DESIGN REVIEW APPLICATION | DESIGN ADJUSTMENTS

SGA PROJECT NO. 20-119

Design Review Application **DR-23-01**
Design Adjustments in Response to
Comments from June 13th, 2023 HRB Meeting

1 GROUND FLOOR PLAN + WILLAMETTE FALLS DRIVE ELEVATION

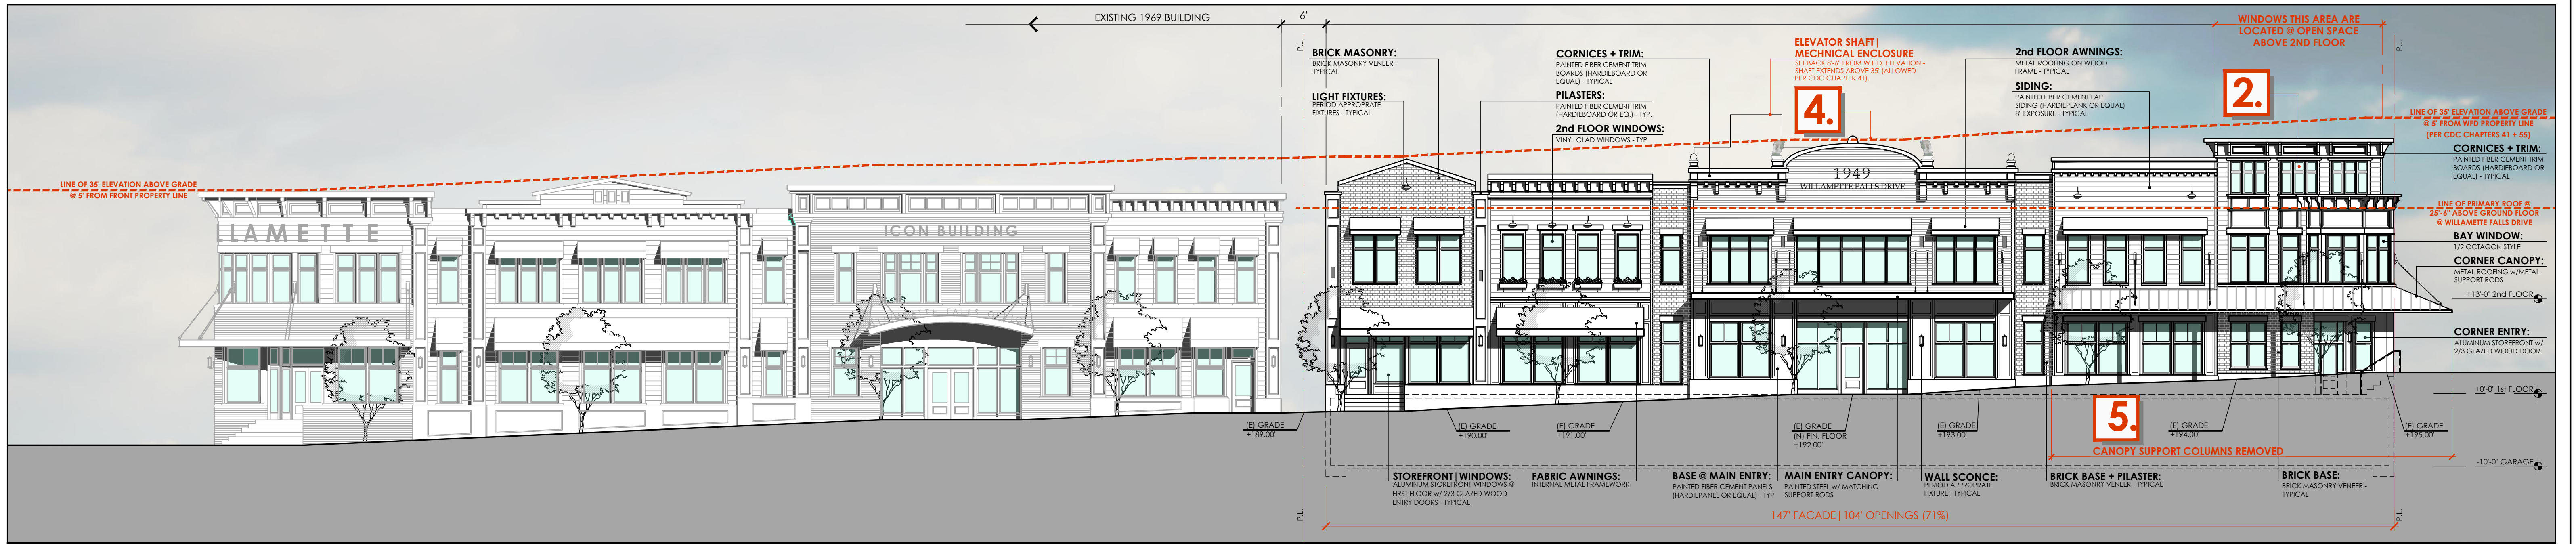
3. CONCERN: The Board was concerned that the drawing showing the Willamette Falls Drive elevation did not show clearly enough that the building elevation meets the 35' height limit required by the Standards. Per Section 41.005 "Determining Height of Building" and Section 58.080.C.3 of the WFDCD:

3. As shown, the proposal is in full compliance with the standards of Chapters 58 and 41.
4. CONCERN: *The City Engineering Department expressed concern that cast iron columns shown supporting the canopy that wraps the northwest corner of the building could conflict with utilities located beneath the sidewalk and could perhaps create an accessibility issue for pedestrians using the sidewalk.*

1. The height limit in the WFD district is 35' per CDC Section 58.080.B.3, and is measured at grade, 5' from the front elevation per CDC Section 41.005.A.1. Exhibit EL05.1 "Willamette Falls Drive Elevation", Exhibit EL05.2 "West (12th Street) Elevation", and Exhibit EL05.3 "Knapps Alley Elevation" show heavy dashed red lines indicating the 35' maximum height on those streets/elevations. Note that while 58.080.B.3 allows parapets to extend above the height maximum, we have nonetheless reduced the parapet heights to fall fully beneath the 35' dimension.

1. The cast iron columns that were supporting the canopy at the northwest corner have been eliminated. In their place, tie-back rods connecting the top of the canopy to the building will be used to support the canopy. This design is the same as that which was approved by the HRB and neighborhood for the existing 1969 Willamette Falls Drive building.

4. THE HEIGHT LIMIT IN THE WFD DISTRICT IS 35' (CDC CHAPTER 58), AND IS MEASURED AT GRADE, 5' FROM THE FRONT ELEVATION (CDC CHAPTER 41). A HEAVY DASHED RED LINE SHOWS THE 35' HEIGHT ON THE WFD ELEVATION. CHAPTER 58 ALLOWS PARAPETS TO EXTEND ABOVE THE HEIGHT MAXIMUM, WE HAVE REDUCED THE PARAPET HEIGHT ON WFD AND 12TH STREET TO FALL FULLY BENEATH THE 35' LIMIT.

5. THE CANOPY SUPPORT COLUMNS HAVE BEEN ELIMINATED AS REQUESTED BY ENGINEERING. THE CANOPY WILL BE SUPPORTED BY TIE-BACK RODS MATCHING THOSE ORIGINALLY APPROVED ON THE 1969 WFD BUILDING.
